Project	IEEE 802.16 Broadband Wireless Access Working Group < http://ieee802.org/16 >
Title	For comment#1012: Adjusting figure 17c – GPCS Layering Model
Date Submitted	2006-05-10
Source(s)	Achim Brandt, Maximilian Riegel Siemens AG Achim.Brandt@siemens.com
Re:	Showing figure 17c explicitly, with the changes proposed in Comment #1012
Abstract	Adjusting figure 17c by removing the boxes representing the interfaces for the particular protocols labeled 'IPv4 over 802.16', 'IPv6 over 802.16', 'IEEE802.3/Ethernet over 802.16', '802.1Q/VLAN over 802.16'. - Rename 'Multiple protocols over 802.16' into 'Multiple protocols encapsulation'
Purpose	For approval as part of Comment #1012
Notice	This document has been prepared to assist IEEE 802.16. It is offered as a basis for discussion and is not binding on the contributing individual(s) or organization(s). The material in this document is subject to change in form and content after further study. The contributor(s) reserve(s) the right to add, amend or withdraw material contained herein.

Introduction

Protocol structure with the Generic Packet Convergence Sublayer (GPCS)

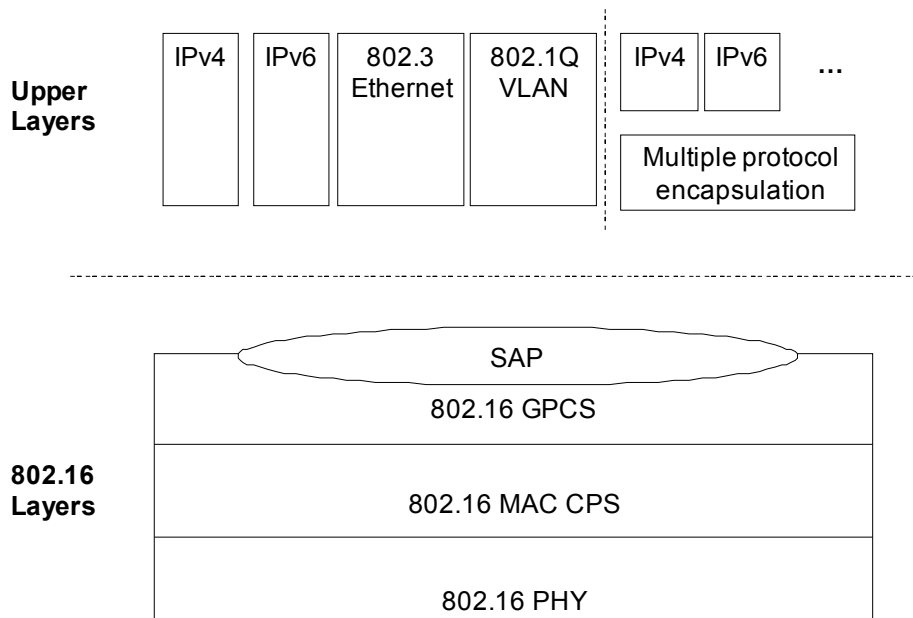
Comment #1012 proposes this remedy:

- Adjust figure by removing the boxes representing the interfaces for the particular protocols labeled 'IPv4 over 802.16', 'IPv6 over 802.16', 'IEEE802.3/Ethernet over 802.16', '802.1Q/VLAN over 802.16'.
- Rename 'Multiple protocols over 802.16' into 'Multiple protocols encapsulation'

This contribution shows how **Figure 17c** will look like once this remedy is applied. The figure also includes a box “SFID selection” which seems necessary even though not mentioned explicitly in Comment #1012.

Corresponding Change to figure 17c in 802.16g/D2, page 10
